# Submittal #140000-4.0 140000 - CADILLAC ELEVATOR

Project: J09202.110 - Empire Buick/GMC & Cadillac  
45-02 Northern Boulevard  
Queens, New York 11101

## 14B - Parkmatic - Carlift - Shop Drawing

TITLE: CIVIL WORKS

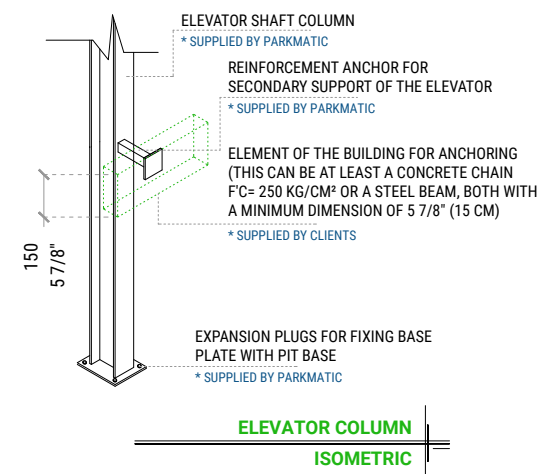
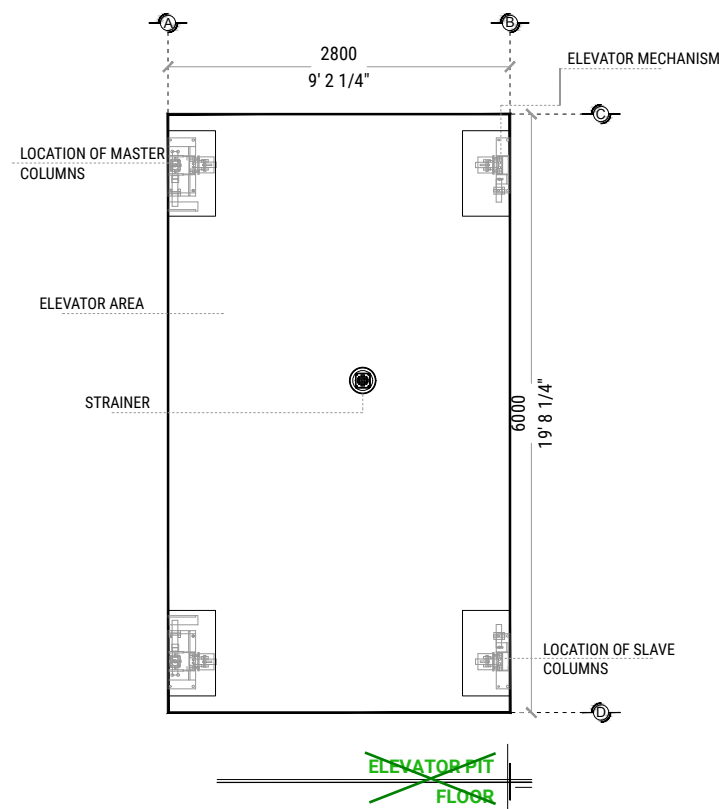
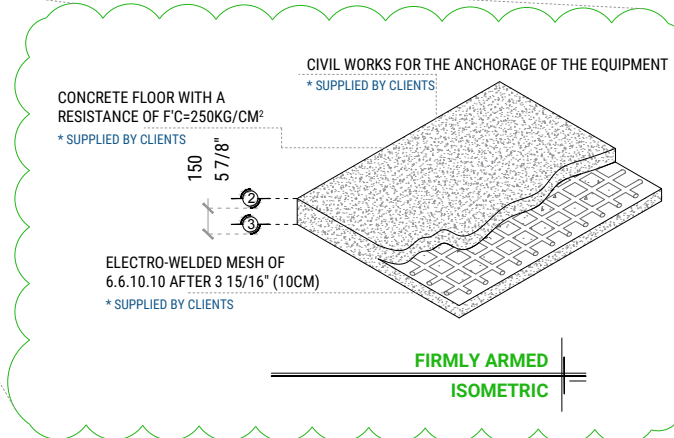
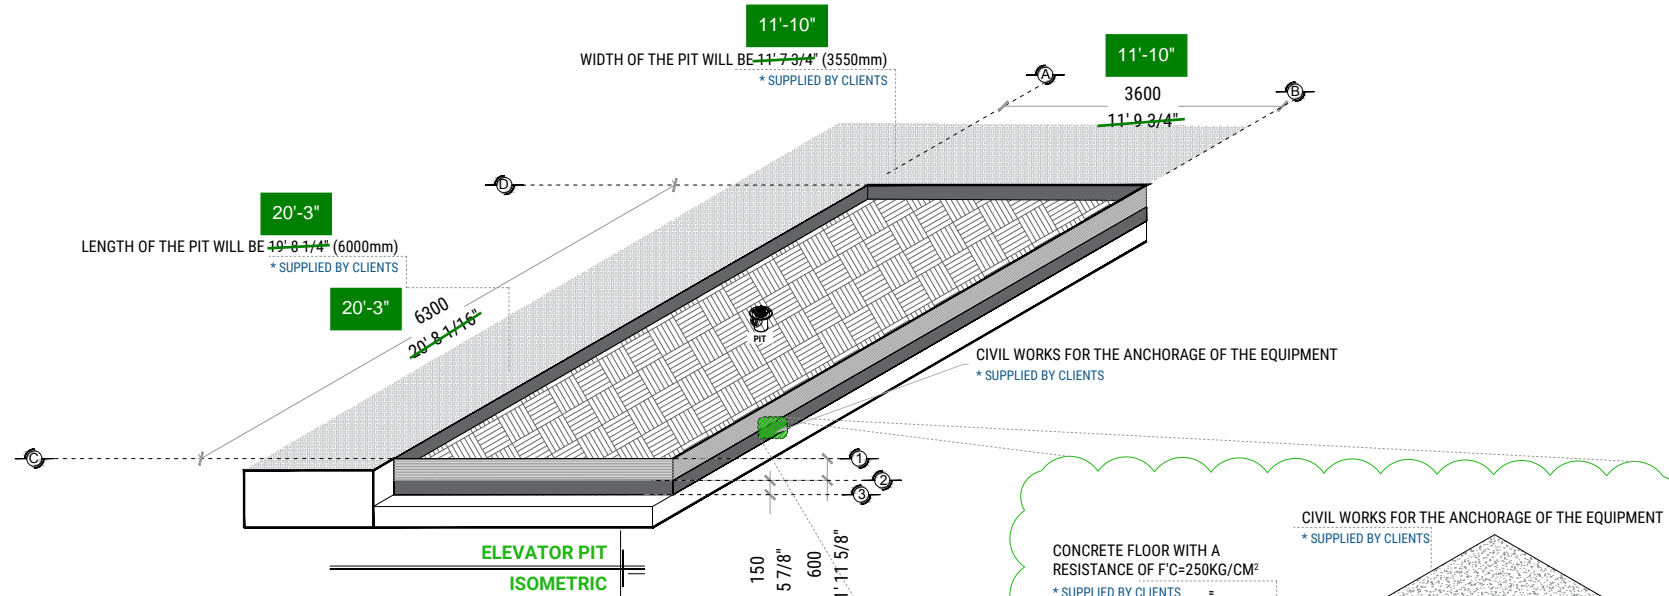
WM: ISN'T THIS THE LIFT PLATFORM? THE PIT IS 11'-10" x 20'-3"

GBC Notes per review with Parkmatic Car Lift Provider:

- Car Lift gets filed as VRC lift (material handling lift), so does not/should not require elevator code checklists/signoff

- As long as this lift is shown on the stamped drawings included with the DOB New Building permit, this lift does not get filed separately or inspected. (not like a passenger elevator)

Design Team (Bohler) please confirm the above

# HYDRAULIC UNIT

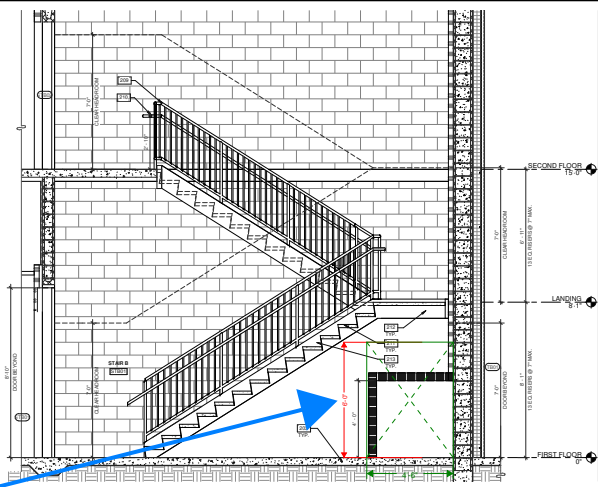
Duct refers to Direct from motor to lift.

No exhaust, supply, or electrical pathway through nook wall is needed for the motor.  
- GBC 3/20/23

DESCRIPTION OF HYDRAULIC UNIT  
CABINET (FRONT VIEW)

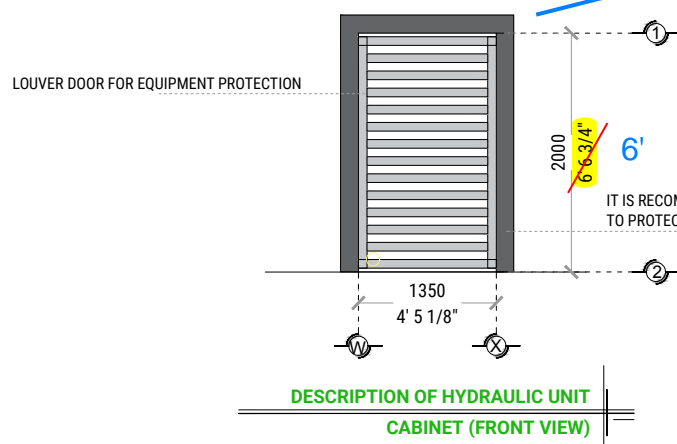
SDG: Review with Gilbane in field. To achieve 4' 6" length, CMU walls will need to be built per modified detail to the right.  
- GBC 3/20/23

WM: 3'-6" IS THE MAX. AVAILABLE

SDG: Needs to be 3' 6" atleast. Use 3' 6" - GBC 3/20/23

Generic lift details noted 10HP, but Cadillac project specs require a 20HP due to the speed of lift  
- GBC 3/20/23

Noted. Car lift electrical will be designed based on 20HP requirements

Note for Syska Electric: Non-fused quick disconnect with ground/neutral. 100A, 3 phase.

DESCRIPTION OF HYDRAULIC UNIT  
CABINET (FLOOR VIEW)

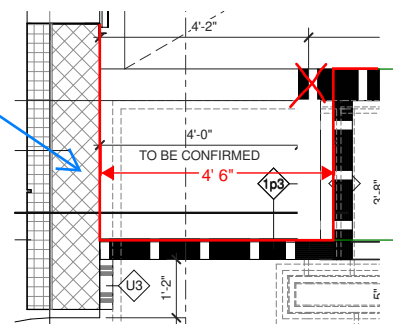
WM: 3'-6" IS THE MAX. AVAILABLE

TITLE: SAFETY, REQUIREMENT AND SPECIFICATION  
SCALE: N/A DATE: 03/14/2023 DRAWN: CHECKED:  
DRAWING NO: FVE-4340NORTHERN-04 SHEET: 4 OF 5

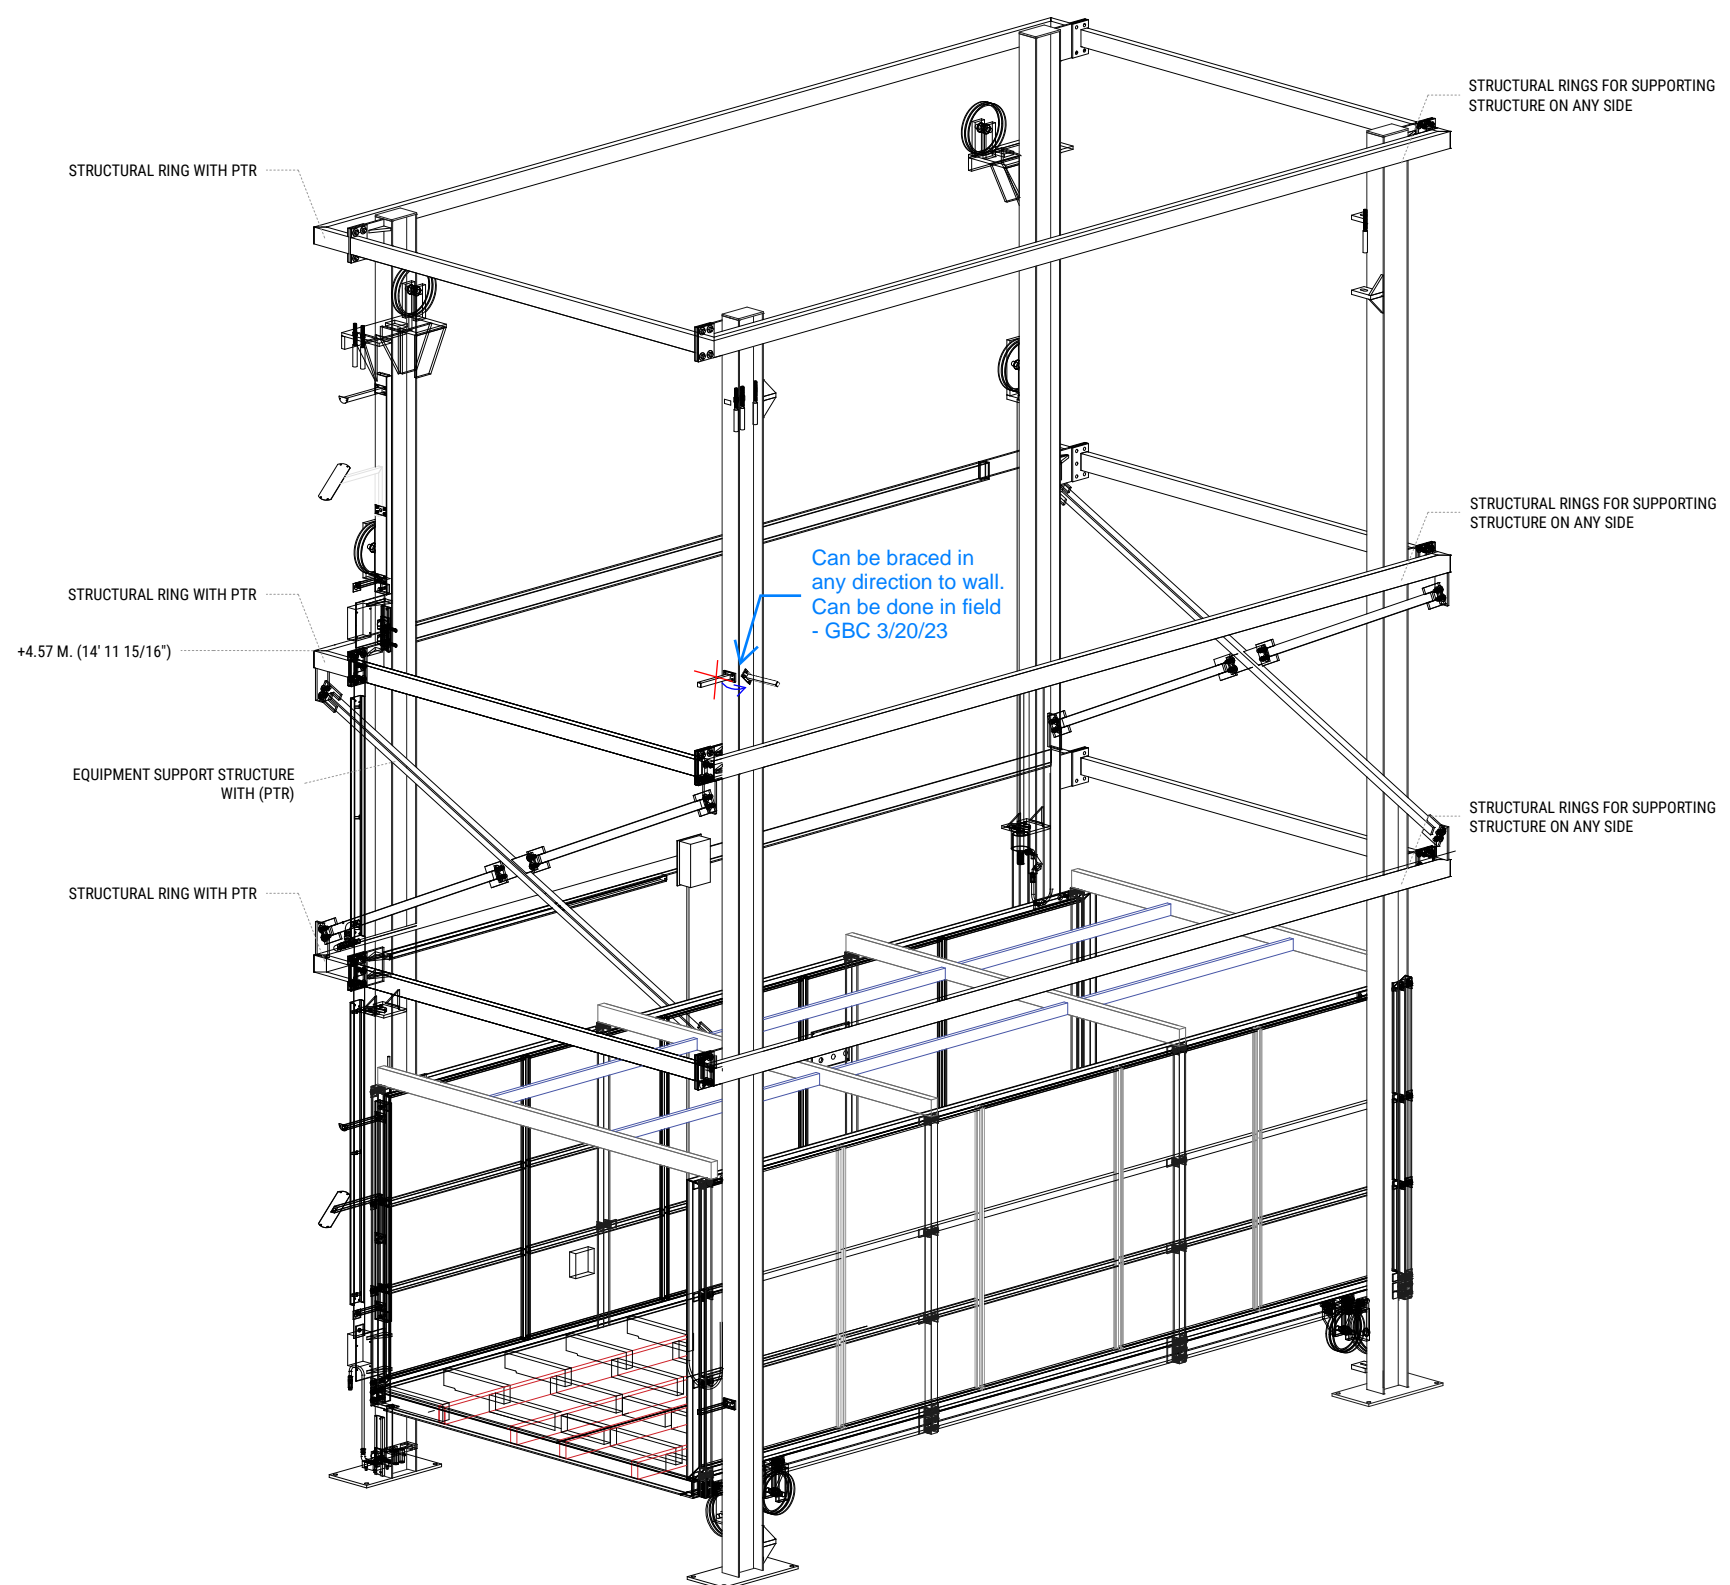
Specifically for welding machine  
Not for permanent.  
- GBC 3/20/23

TITLE: VOX ELEVATOR LAYOUT  
 SCALE: N/A DATE: 03/14/2023 DRAWN: CHECKED:  
 DRAWING NO: FVE-4340NORTHERN-05 SHEET: 5 OF 5

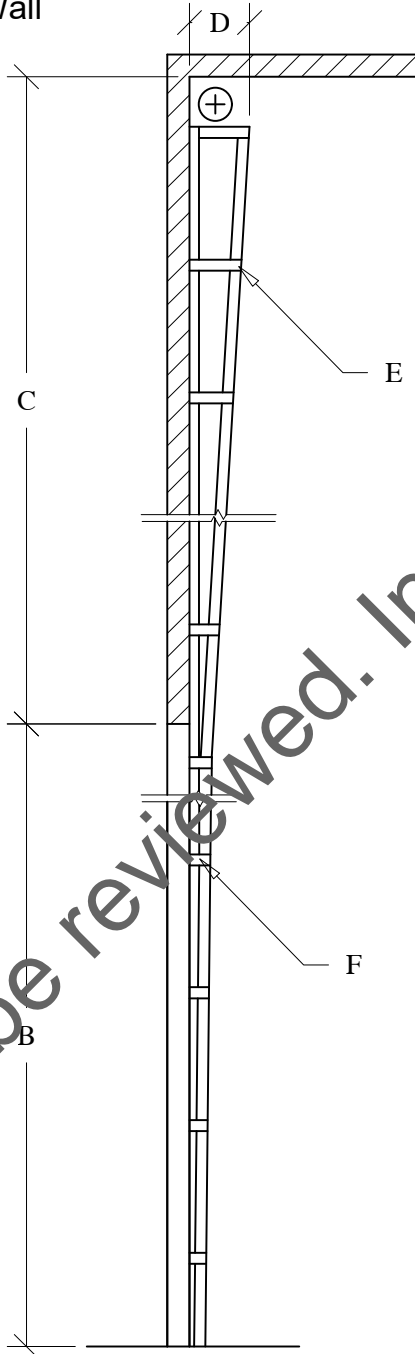
GBC Notes per review with Parkmatic Car Lift Provider:

- Controls are on outside and inside of shaft
- Lift gets programmed by Parkmatic with overhead doors (closed to operate)
- GBC 3/20/23

### Detail Through Wall

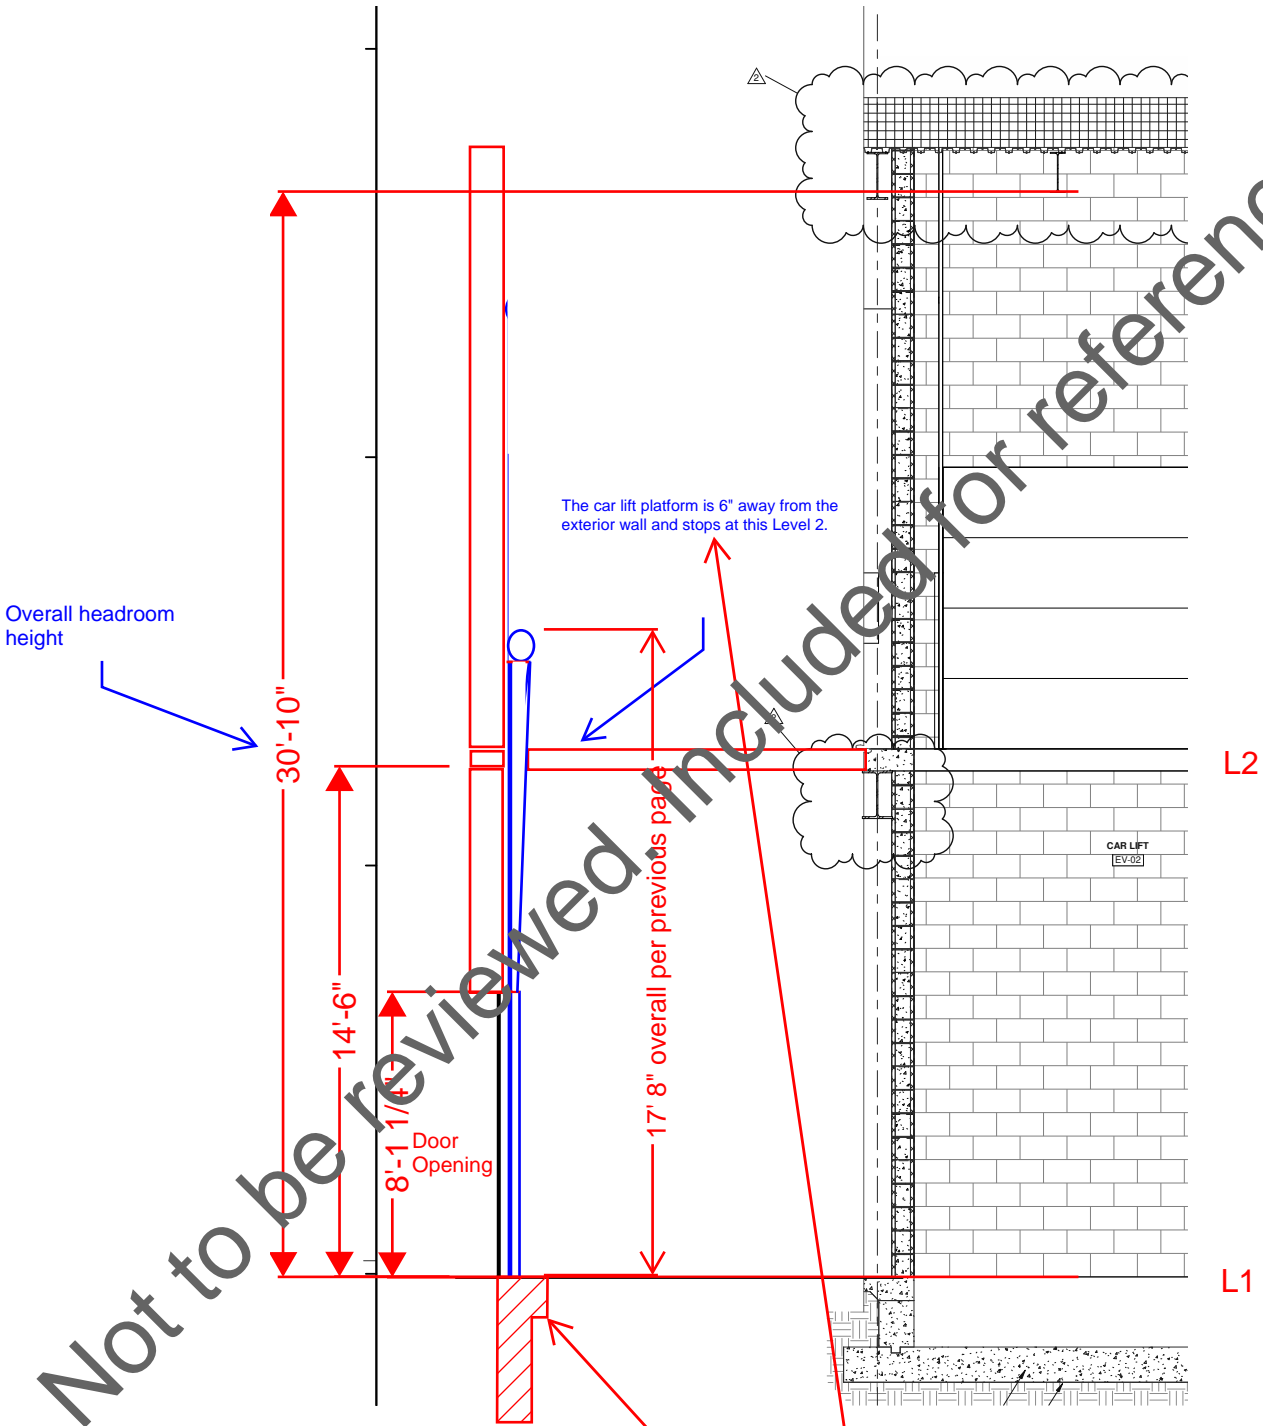
Included to show previous page dimensions overlay with A-404 -GBC 1/3/23

WM:  
 REFER TO STRUCTURAL DRAWINGS. SLAB EDGE EXTENDS 6" INTO CAR LIFT SHAFT ON FIRST FLOOR LEVEL. ACTUAL SIZE OF GAP, IF ANY, TO BE REVIEWED AND ADDRESSED ON THE CAR LIFT SUBMITTAL.
